# RENESAS TECHNICAL UPDATE

Product Category	MPU & MCU	Document No.	TN-16C-A234A/E	Rev.	1.00
Title	Errata to R32C/152 Group User's Manual: Hardware		Information Category	Technical Notification	
Applicable Product	R32C/152 Group	Lot No.	Reference Document	R32C/152 Group User's Manual: Hardware Rev. 1.10 (REJ09B0504-0110)

This document describes corrections to the R32C/152 Group User's Manual: Hardware, Rev. 1.10. The corrections are indicated in red in the list below.

Figure 7.1 Clock Generation Circuitry

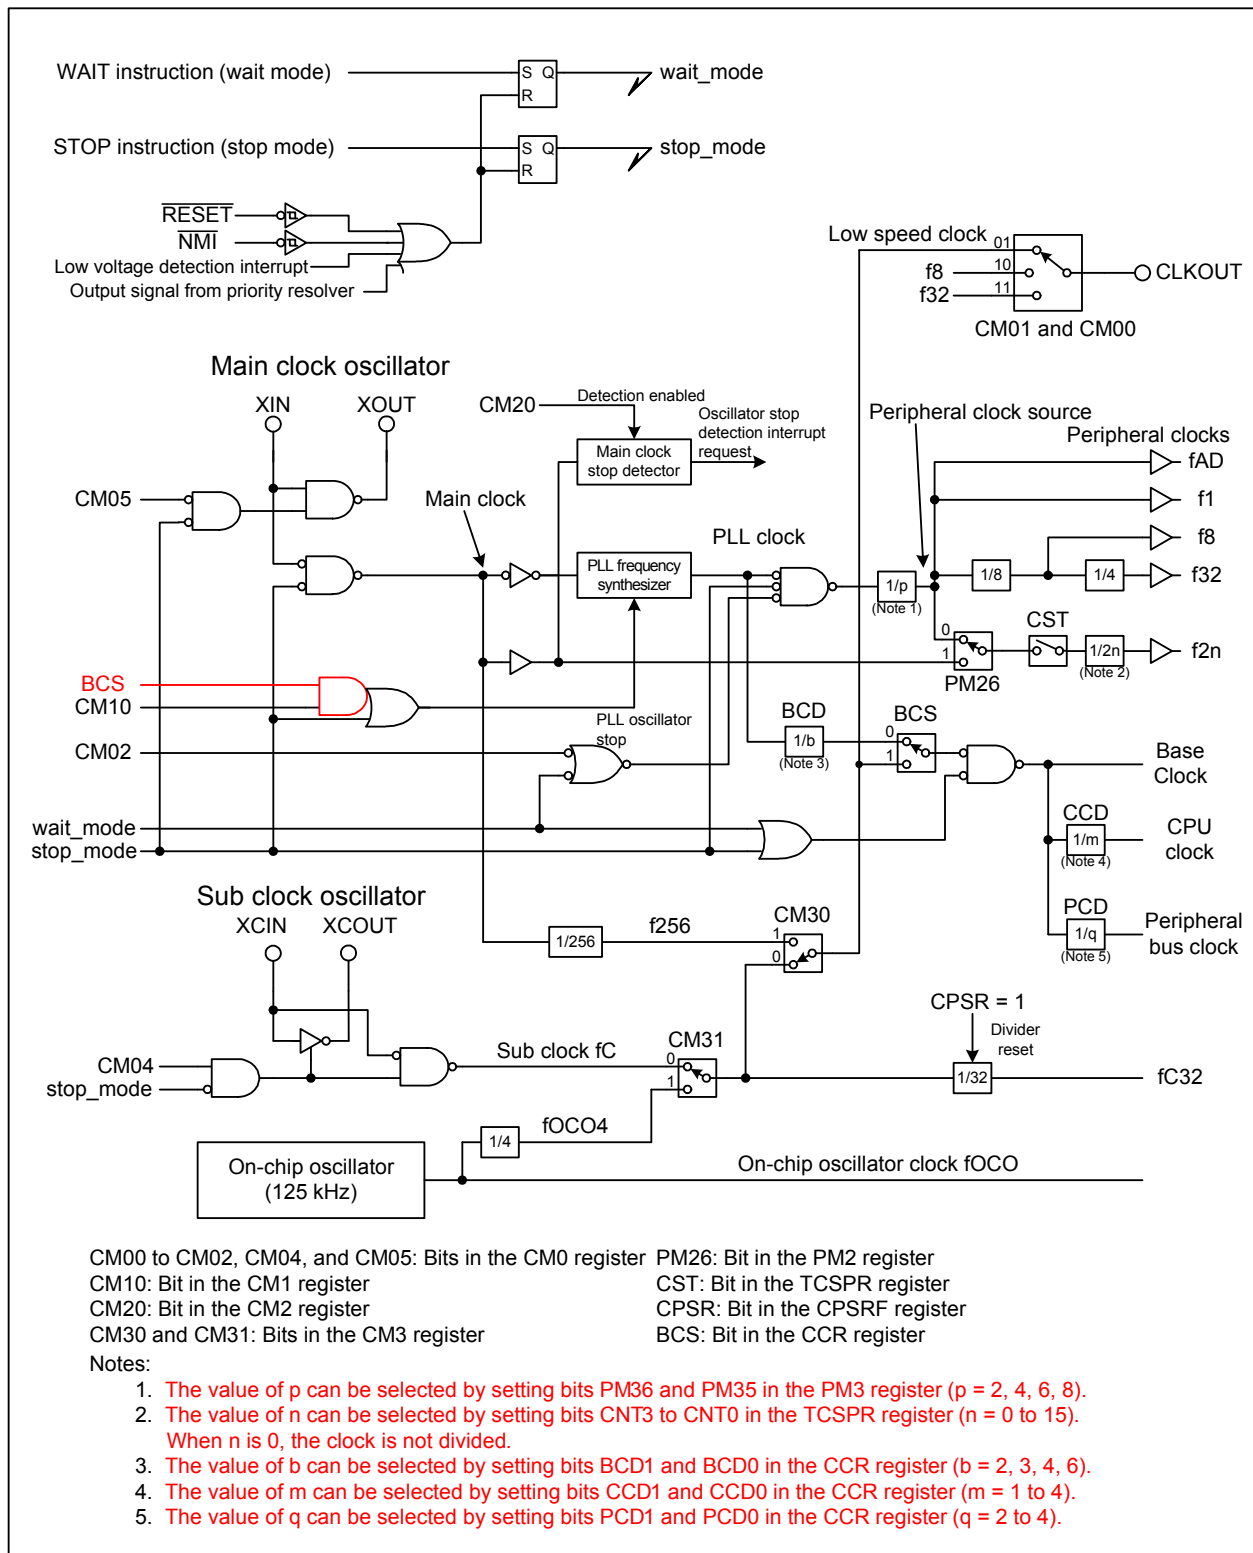
•Page 105 of 642, Figure 7.1 is corrected as follows:

Figure 20.1 CRC Calculator Block Diagram

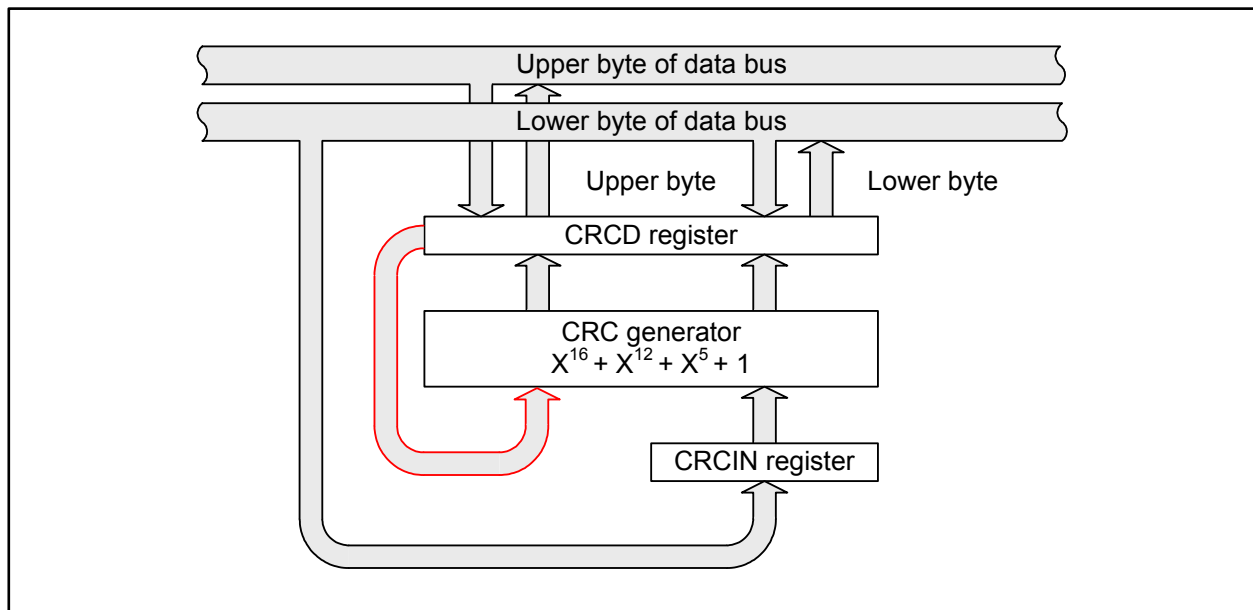
•Page 327 of 642, Figure 20.1 is corrected as follows:

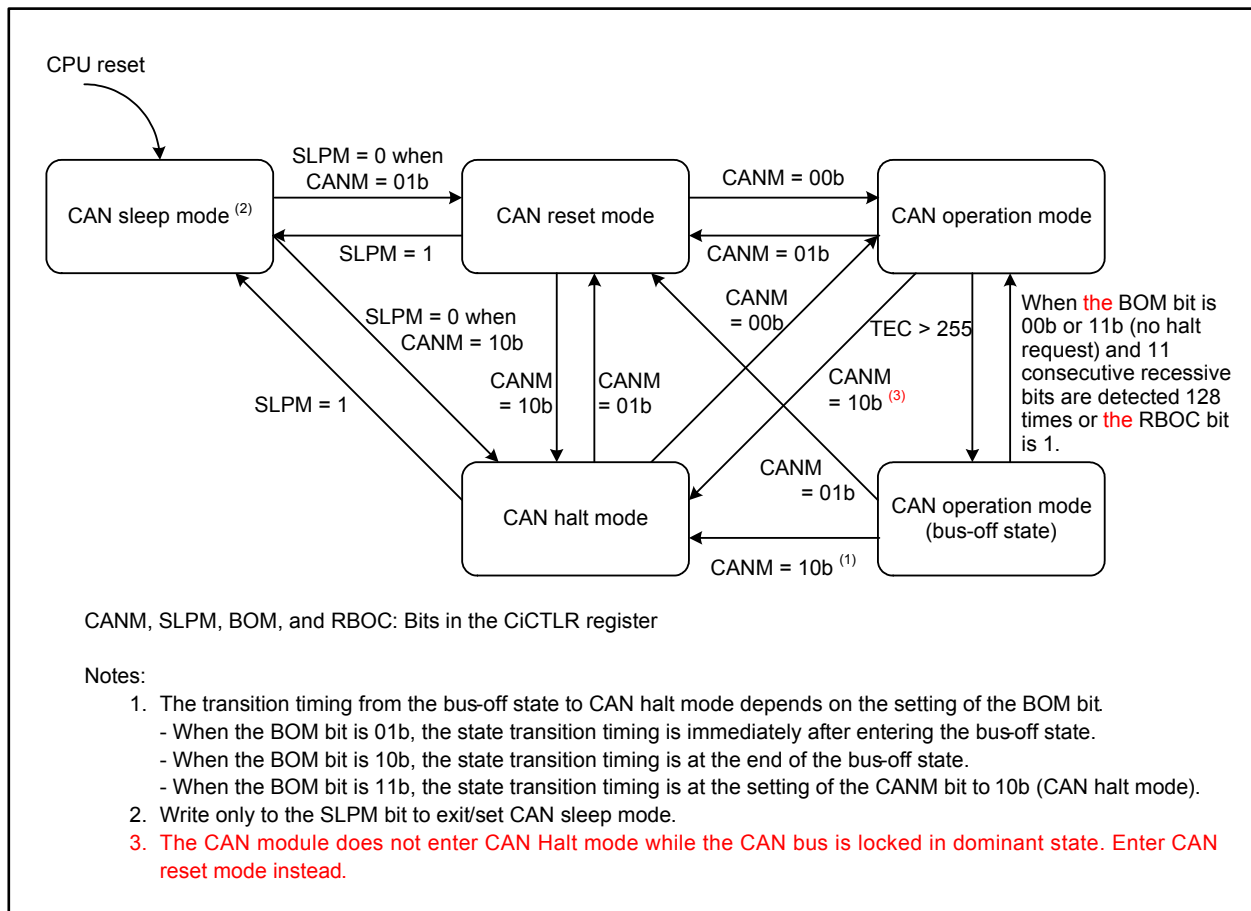
•Page 493 of 642, Note 3 is added to Figure 25.34 as follows (refer to TN-16C-A229A/E):

**Figure 26.1 Typical I/O Pin Block Diagram (i = 0 to 15; j = 0 to 7)**

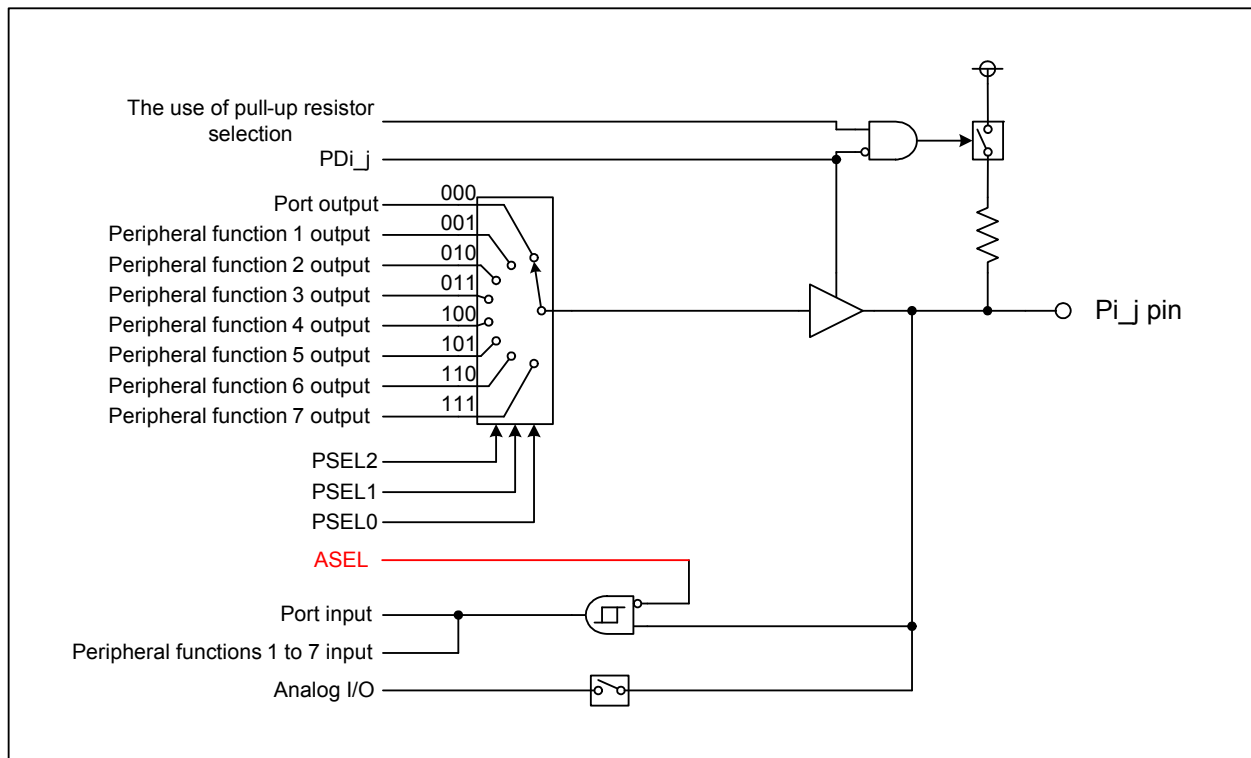
•Page 511 of 642, Figure 256.1 is corrected as follows (refer to TN-16C-A200A/E):
